Office Action Summary	Application No. 10/558,169	Applicant(s) BASCHEK ET AL.	
	Examiner Edu E. Enin-Okut	Art Unit 1795

- 1) ☒ Responsive to communication(s) filed on 13 August 2009.
- 2a) ☒ This action is **FINAL**. 2b) ☐ This action is non-final.
- 3) ☐ Since this application is in condition for allowance except for formal matters, prosecution as to the merits is closed in accordance with the practice under *Ex parte Quayle*, 1935 C.D. 11, 453 O.G. 213.

FUEL CELL AND HEATING DEVICE OF A FUEL CELL

Suzuki, Fig. 6:

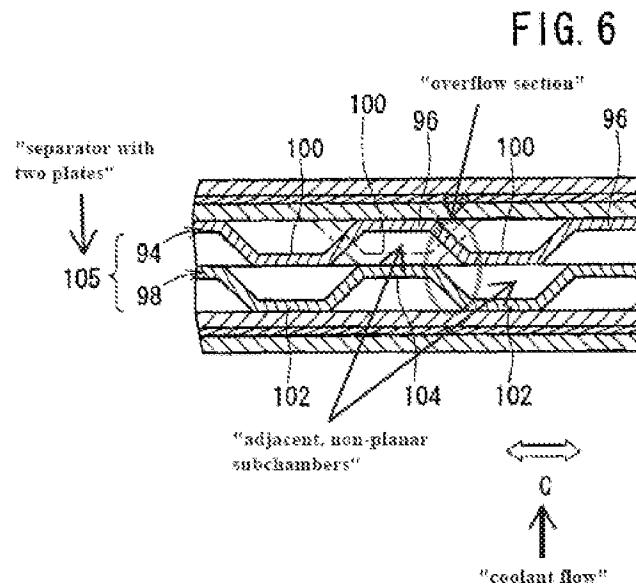
Regarding claims 12, 13, 16, 22, 23 and 28, Suzuki teaches a first separator 94 of a fuel cell unit, composed of an electrolyte electrode assembly 7, and a second separator 98 of another unit cell disposed adjacent to each other in a stacked assembly 90 (Abstract; 1:19-25, 10:53-65; Claim 1; Figs. 5, 6, 7). The separators 94,98, jointly making up a separator unit 105, have first and second hollow ridges 100,104 with straight and bent sections (Abstract; 10:67-11:8; Figs. 6, 7). The second hollow ridges 104 are out of phase with the first hollow ridges 100, i.e., are staggered with respect to ridges 100 (11:12-14). Crest surfaces of straight sections of the separators 94,98 are in contact with each other in regions where they cross, while crest surfaces of the bent sections are spaced apart from one another (11:14-19). The spaced crest surfaces allow separators' troughs 96,102 to communicate with each other, providing communication passages 72 between the first and second separators 94,98 (Abstract; 11:19-24). Cooling water is passed through the communication passages 72 (Abstract; 11:19-24). Fuel gas and oxygen-containing gas flow through the hollow ridges of the separators (3:28-35, 5:61-64; Figs. 6, 7). (See labeled figure from Suzuki below.)

However, one of ordinary skill in the art would appreciate that the separators of Suzuki contacts its unit cell over an amount, or percentage, of its surface area (see Suzuki, Fig. 6). That artisan would also appreciate that the degree of contact of surface area of the separator plates affects the capacity to cool the fuel cell allowing more or less surface area of coolant to flow through. Further, Suzuki does teach that the rate at which the cooling water flows can be adjusted by selecting the shapes of the first and second hollow ridges (12:1-3).
